BID #709 – Ventura College STEM Program Building Improvements

ADDENDUM 001, dated 05/15/2025

DRAWING changes and clarifications noted as Addendum 01 and dated 05/15/2025:

CONCRETE BENCH

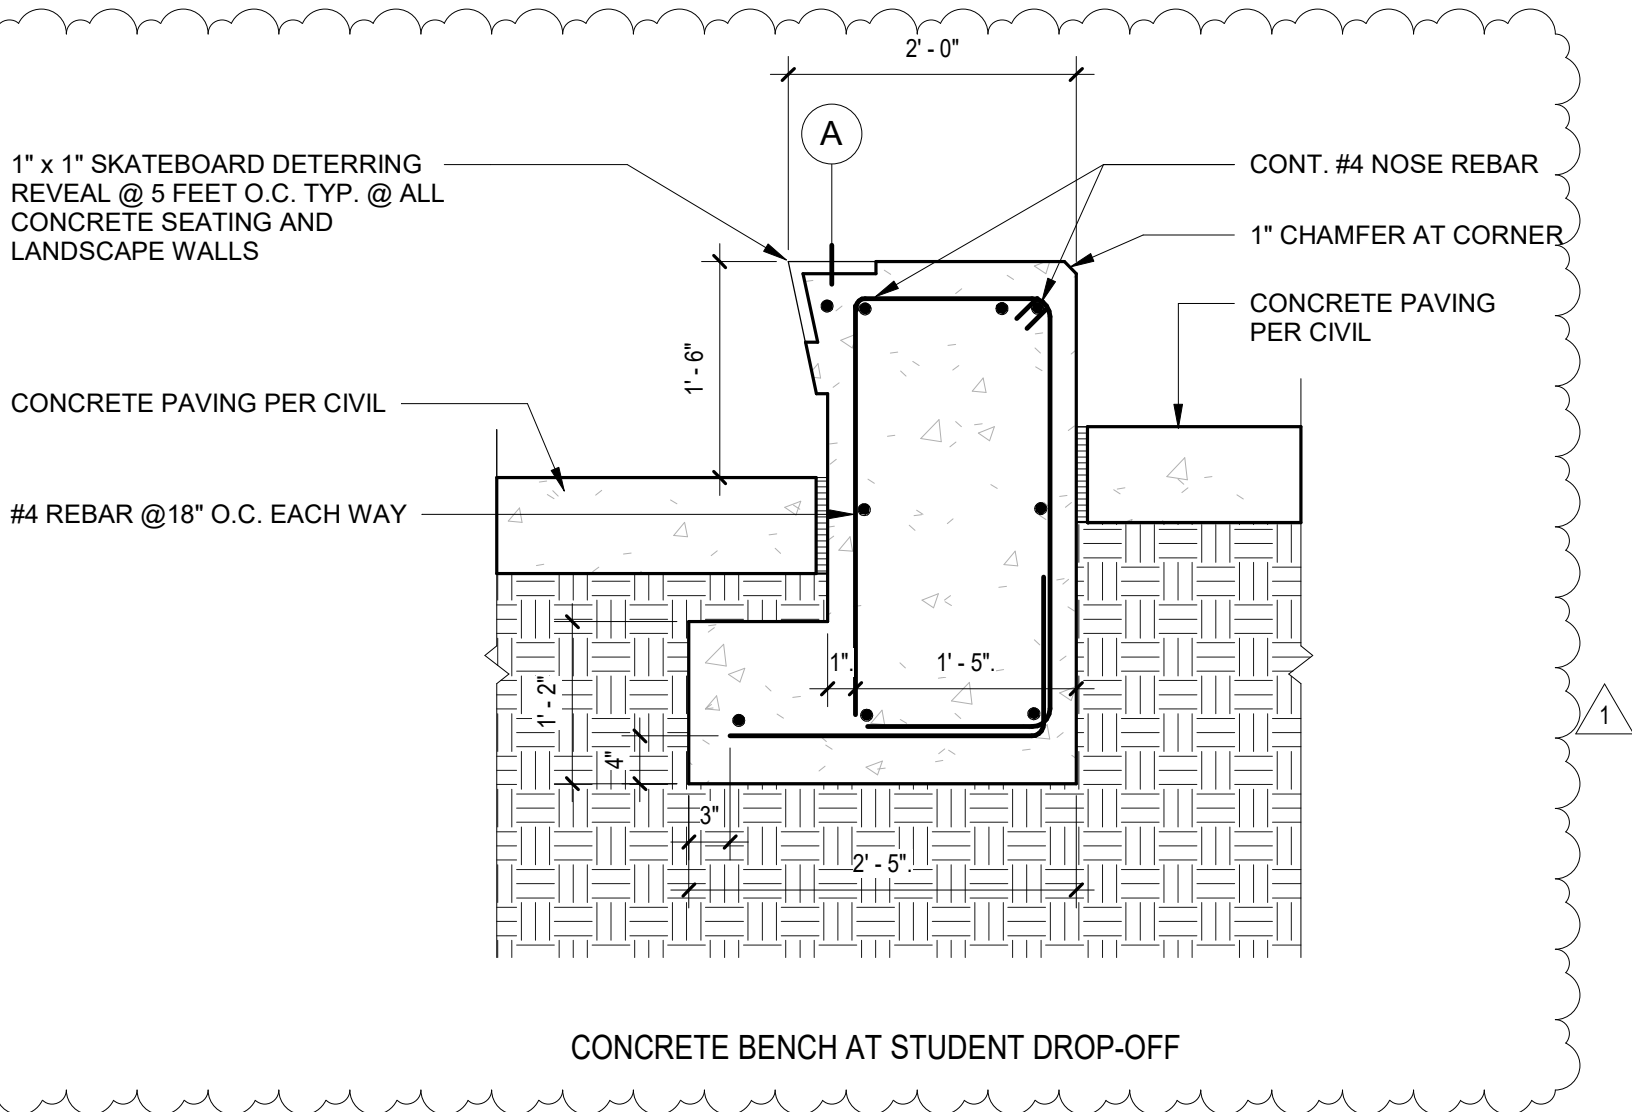
A501 – DETAIL 7/A501, CONCRETE BENCH AT STUDENT DROP-OFF ADDED.

SOUTH ELEVATION SITE

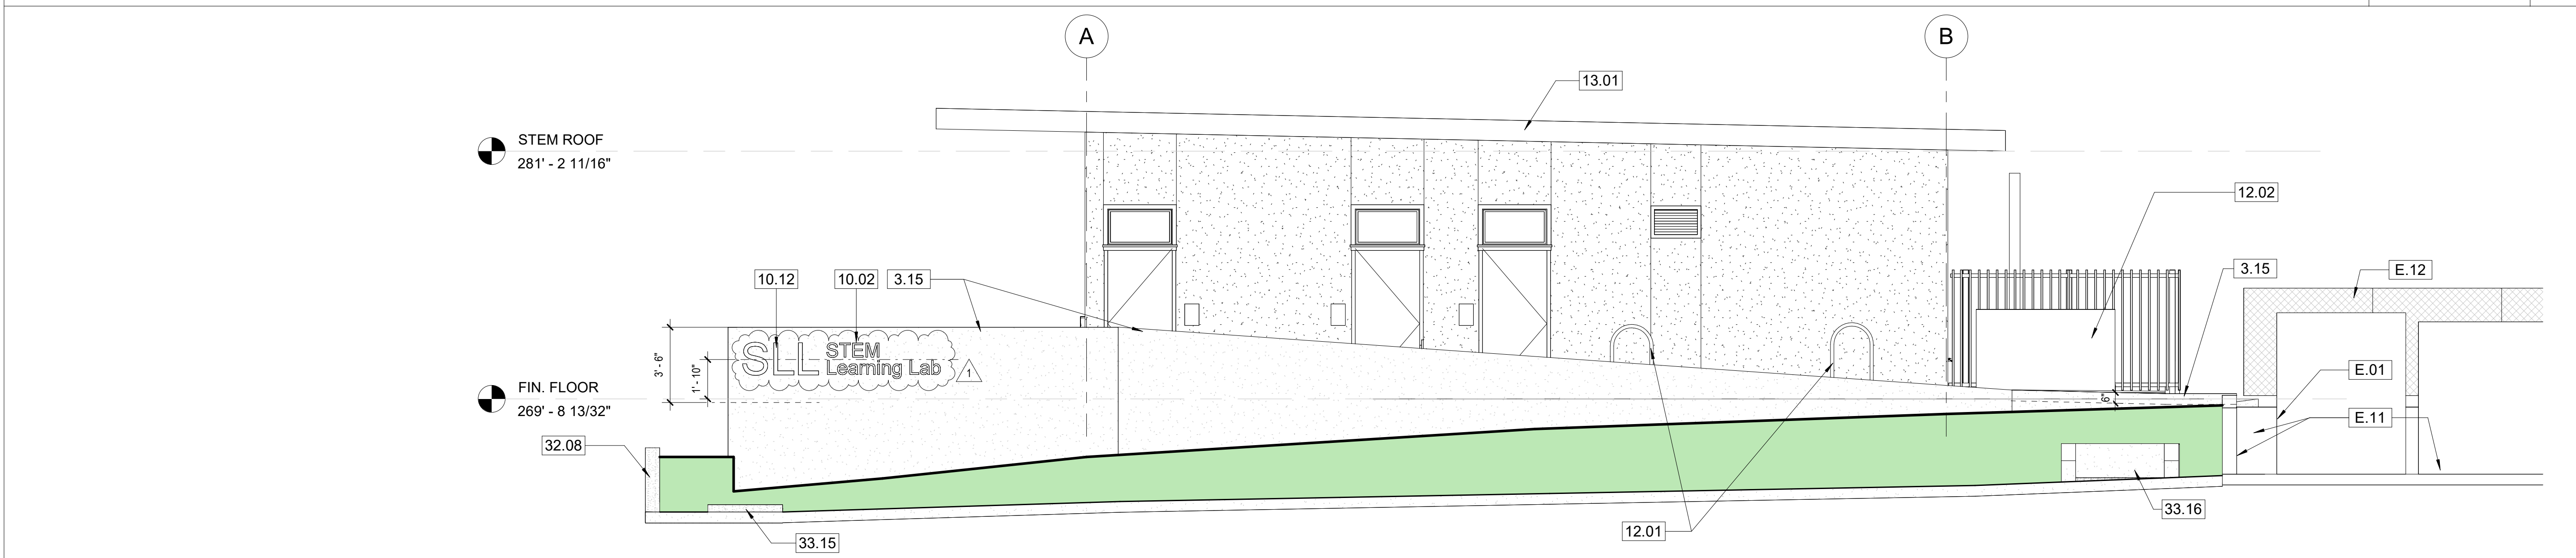
A202 – SITE EXTERIOR ELEVATIONS; 3/A202 SOUTH ELEVATION SITE, KN 10.02 BUILDING SIGN REVISED

DRAWING FILENAME: 22-539E133

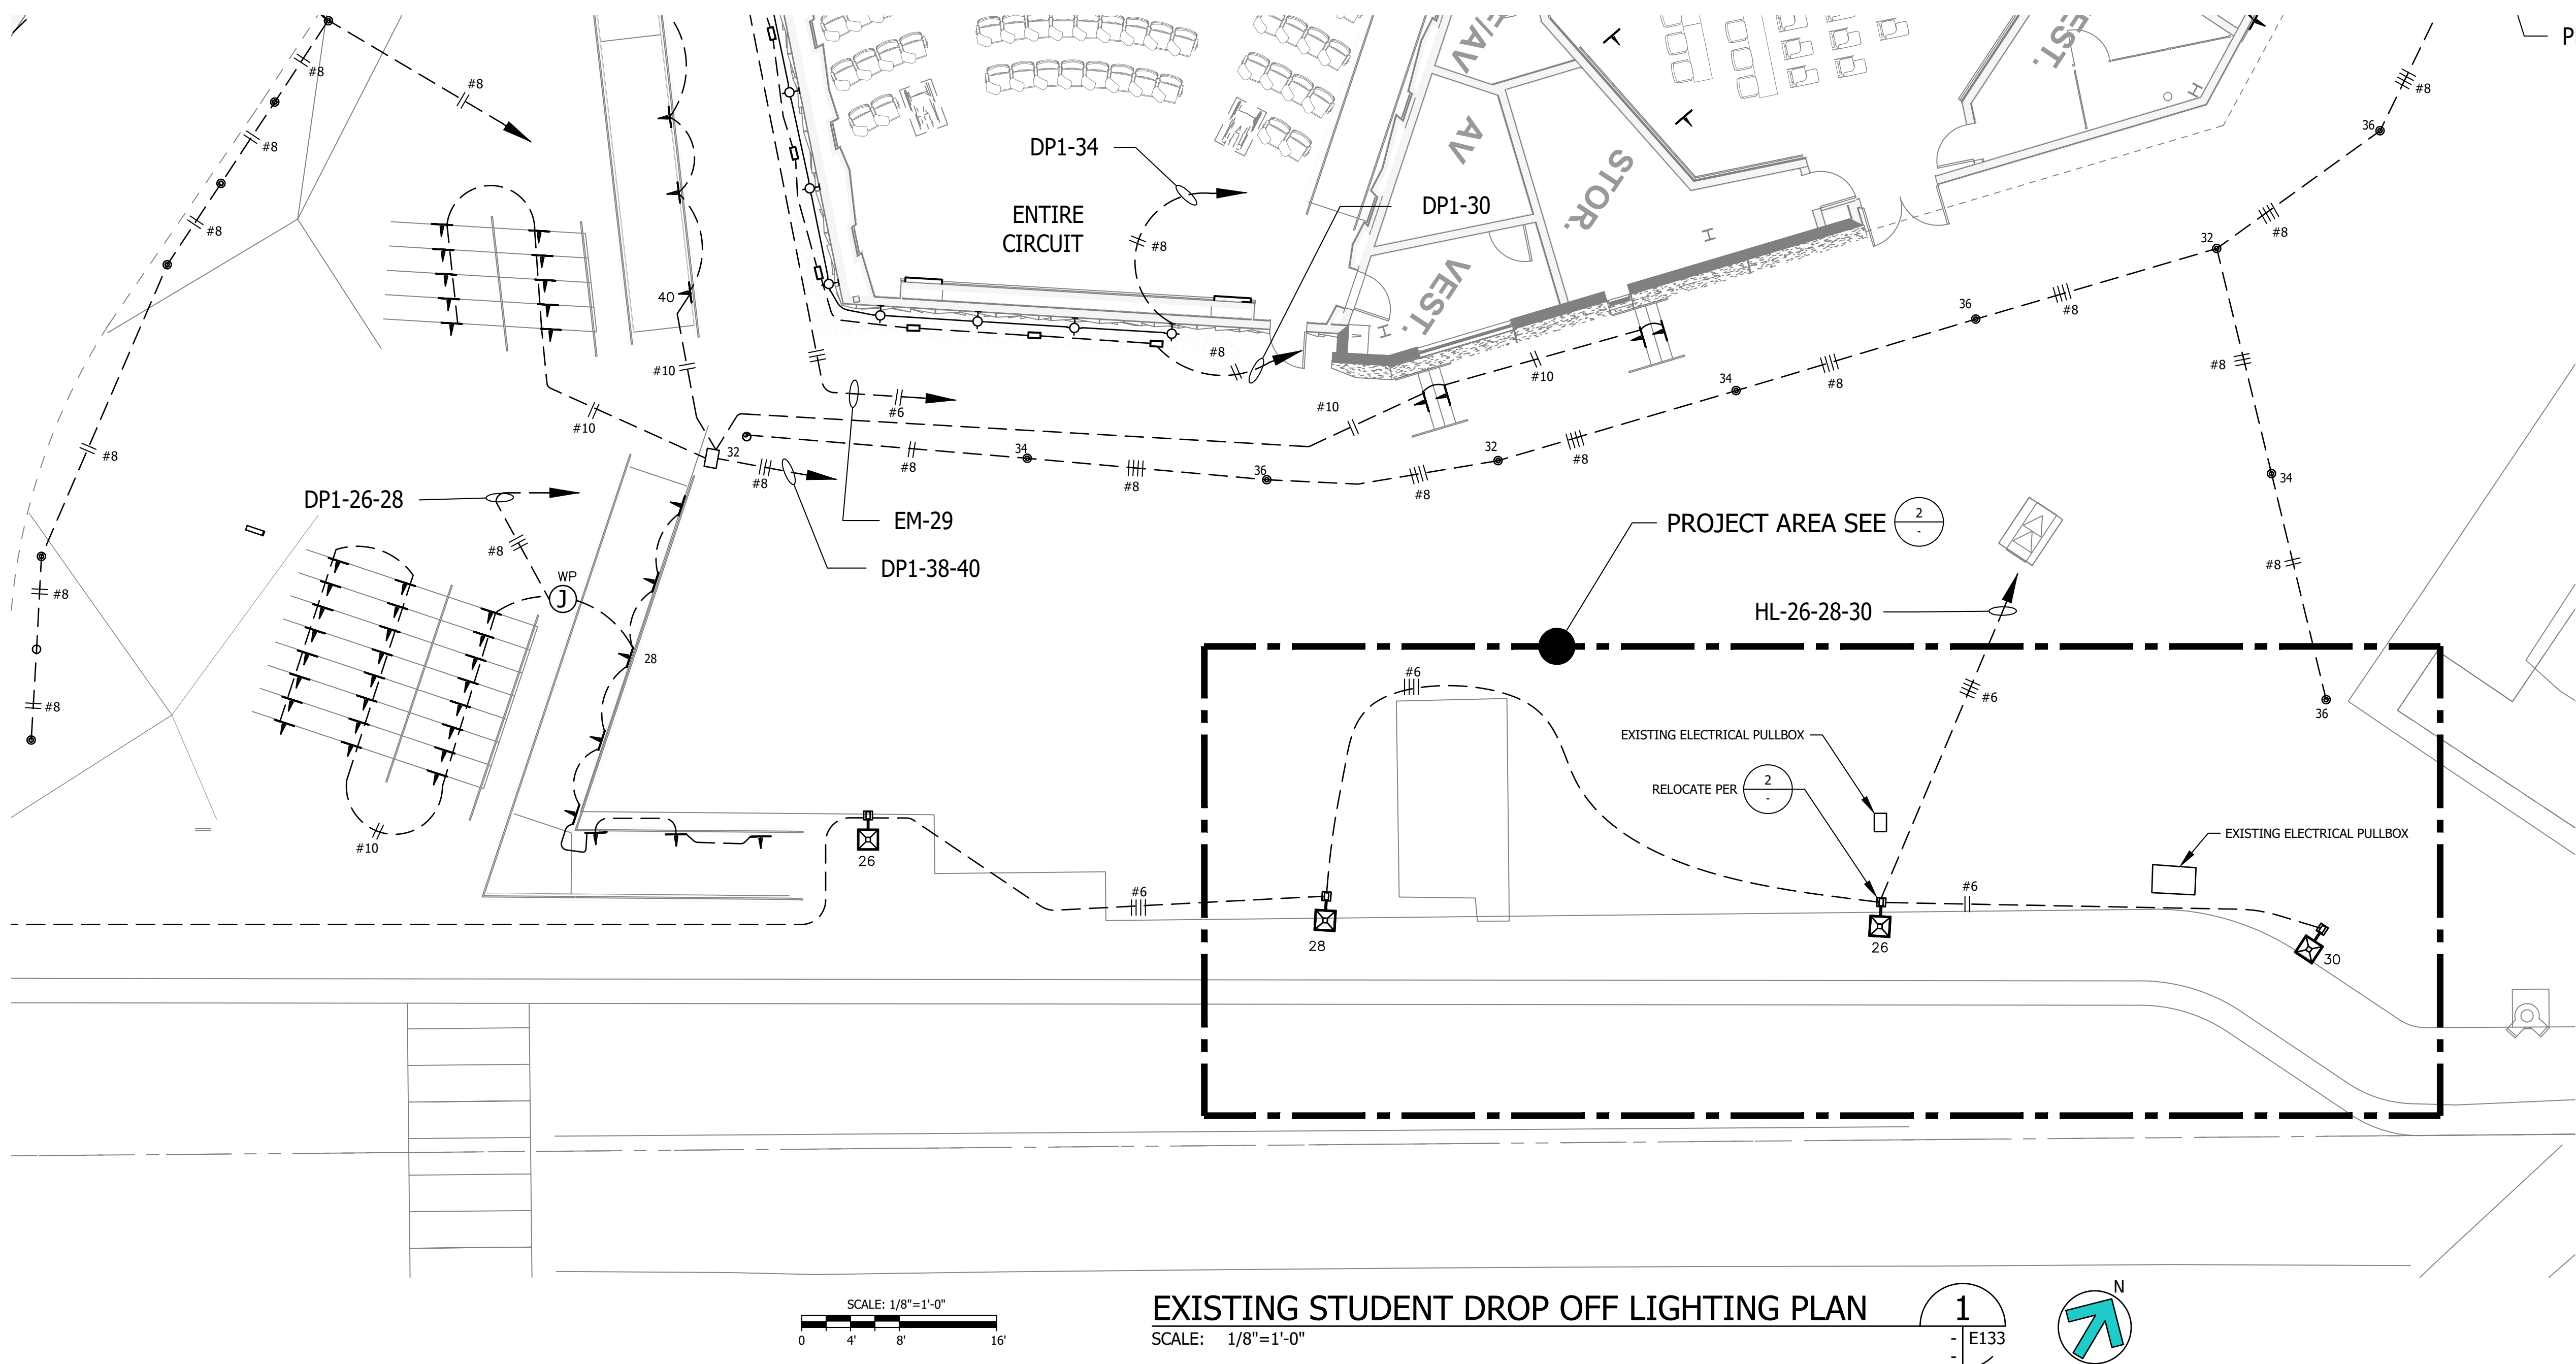
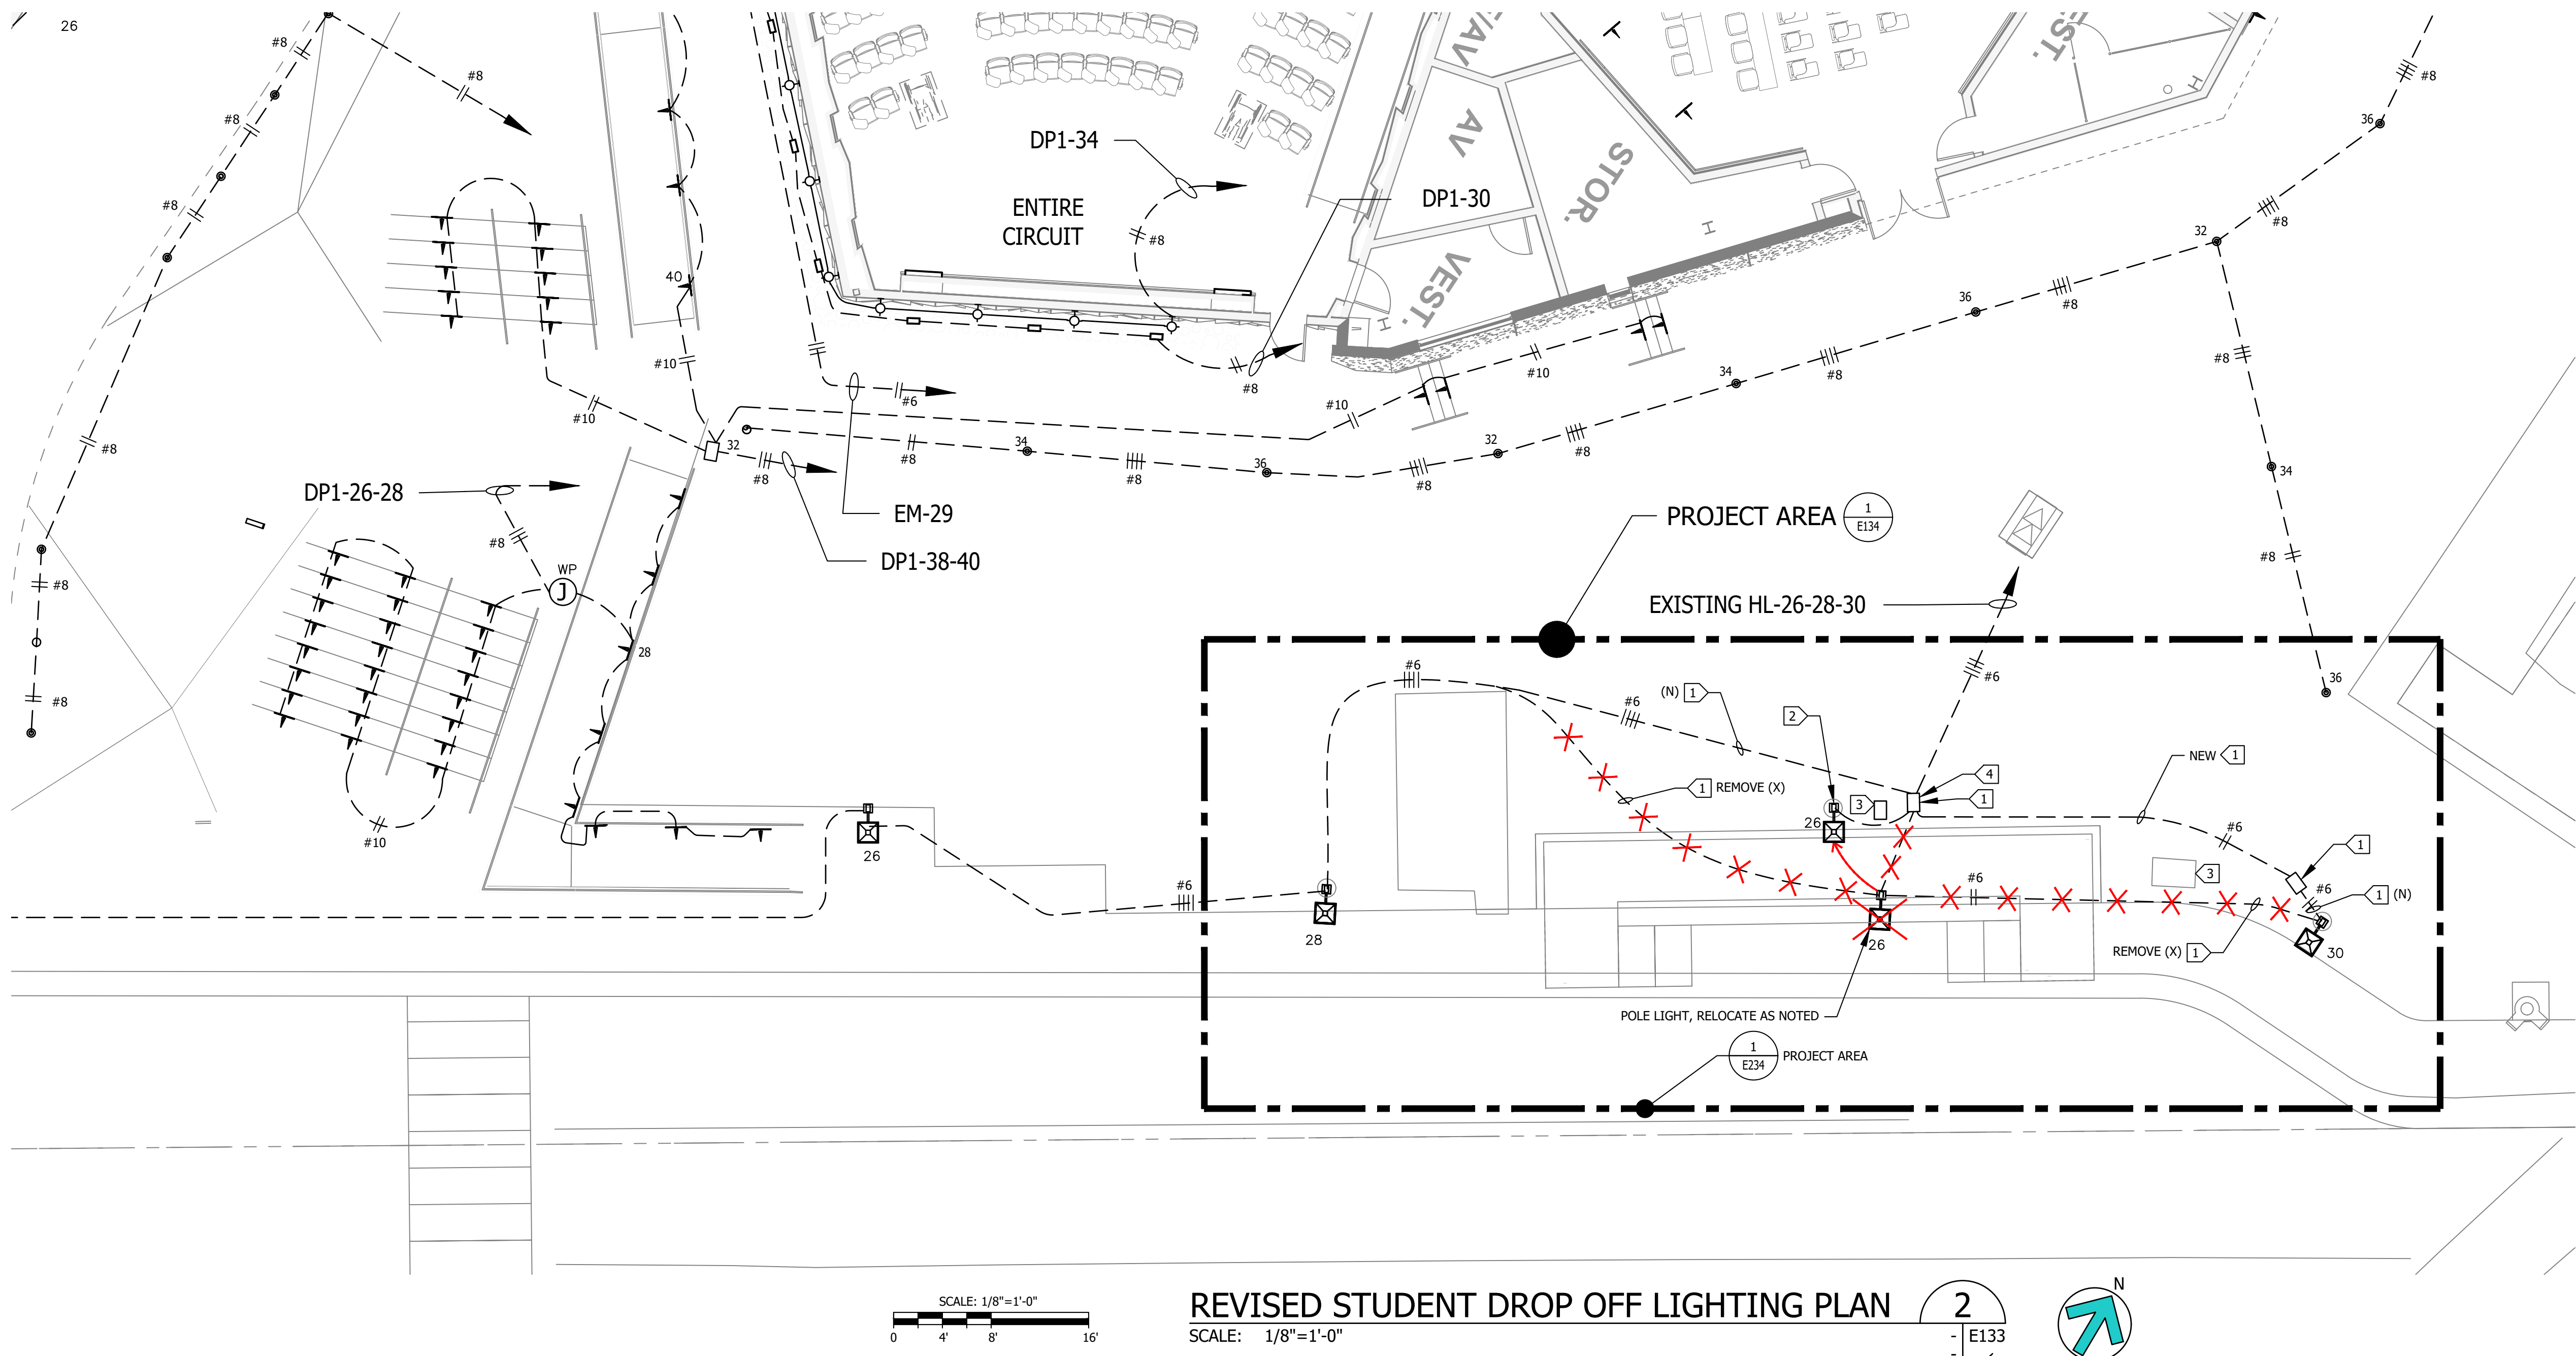
E133 – NEW DRAWING; DROP OFF AREA LIGHTING EXISTING AND REVISED PLAN
